**REDEVELOPMENT OF ABBEY WALL WORKS, STATION ROAD  
Planning application 20/P1412 & Listed Building Consent application 20/P1672**

**A response by Wandle Valley Forum  
June 2020**

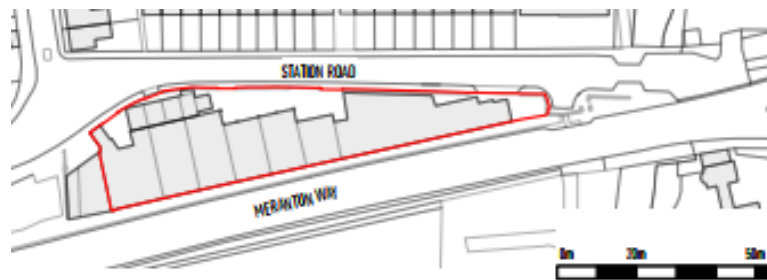
2. Abbey Wall Works is an important location within the context of the Wandle Valley. It occupies a key site in the former estate of Merton Priory, the most significant historic site within the Wandle Valley, and a nationally listed stretch of the Priory Wall forms part of the boundary. The very name of the site recognises its historic role as the main approach to the precinct of Merton Priory. The eastern end is also adjacent to the Wandle river and the Wandle Trail. As can be seen, the boundary of the Wandle Valley Conservation Area was specifically drawn to include this gateway site:

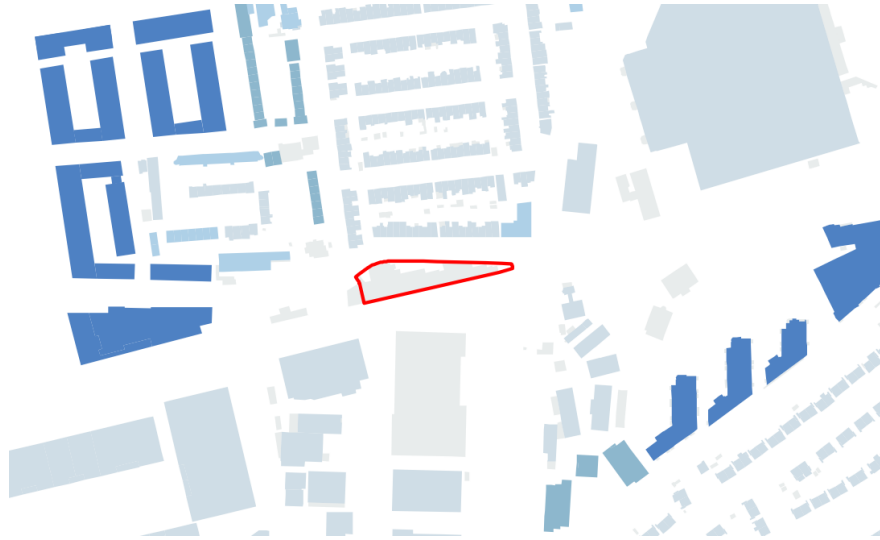
7. We object to the proposed height, mass and design approach. The reduced height and other changes to the proposals from the rejected scheme are insufficient to address the overbearing impact which was a main ground for refusal. The scale of the building makes it a development which draws attention to itself rather than sitting easily within the context of the Wandle Valley and its surroundings. This will have a particular impact on the listed Priory wall which currently runs alongside low rise industrial buildings that have a largely neutral impact. These will be replaced by an overbearing, dominating development that will cause significant harm to this designated heritage asset. It will also negatively impact the experience of users of the Wandle Trail replacing the low key view dominated by a trees and vegetation along the highway boundary shown in the Townscape and Visual Impact Assessment (extract below) with a dominating building. We dispute the claim that this impact is "*beneficial*".
